File WTC 11700

PROJECT: THE WORLD TRADE CENTER | TITLE: TOWER B EL. 284 - NEW SLAB OPENING | DATE: 6-12-72

19-B-1115.1

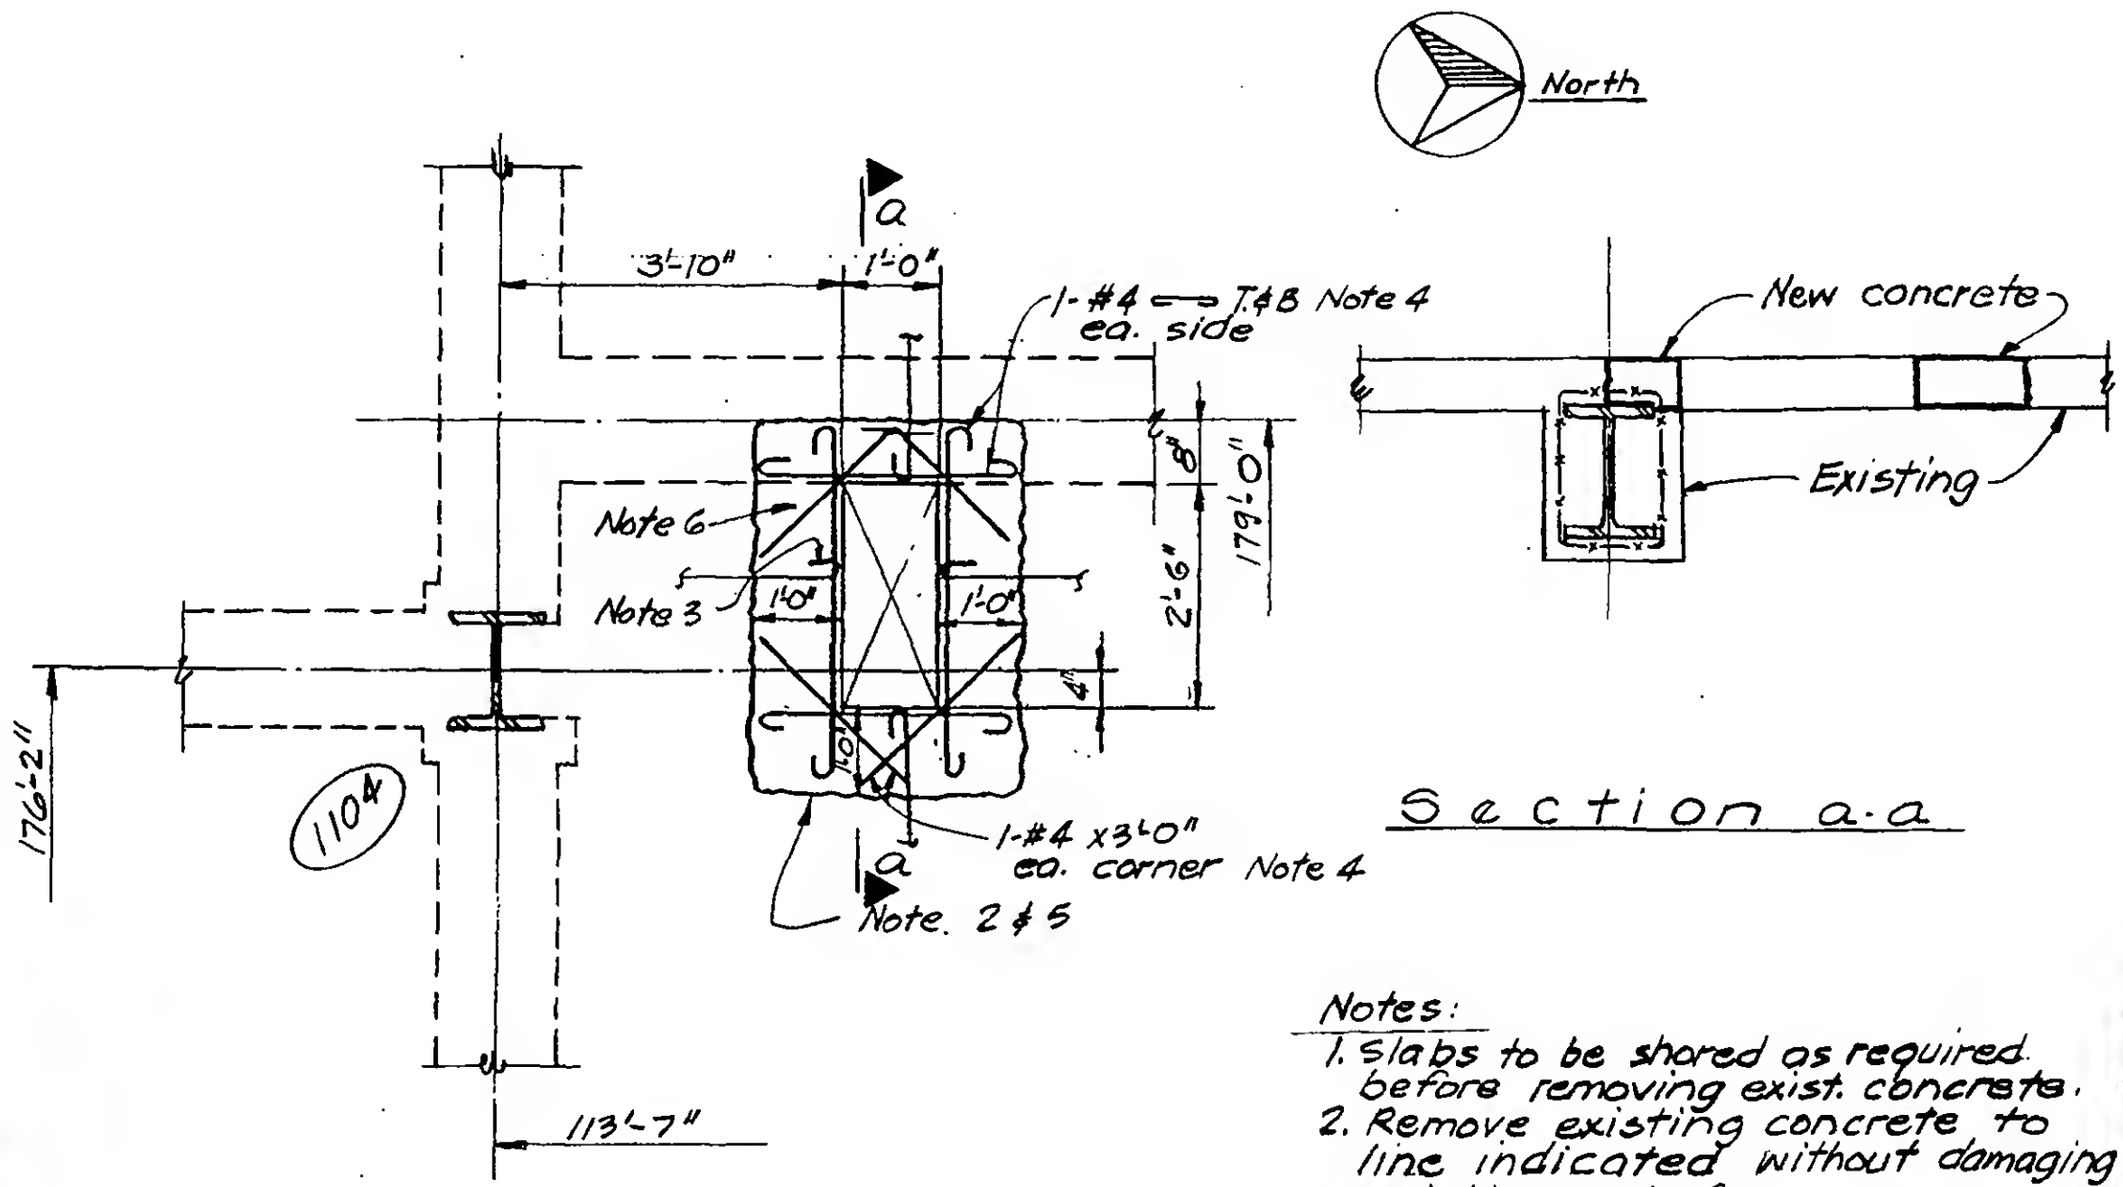
See M-B-10 dated 6-1-72 Bul. No. B-163

1. Slabs to be shored as required before removing exist. concrete.
2. Remove existing concrete to line indicated without damaging existing reinf.
3. Cut existing reinf. and hook at edge of opening.
4. Add new reinf. as indicated.
5. Clean face of existing concrete and thoroughly coat entire surface with epoxy bonding compound.
6. Cast slab to edge of new opening using approved "non-shrink" f'c: 4000 psi concrete.
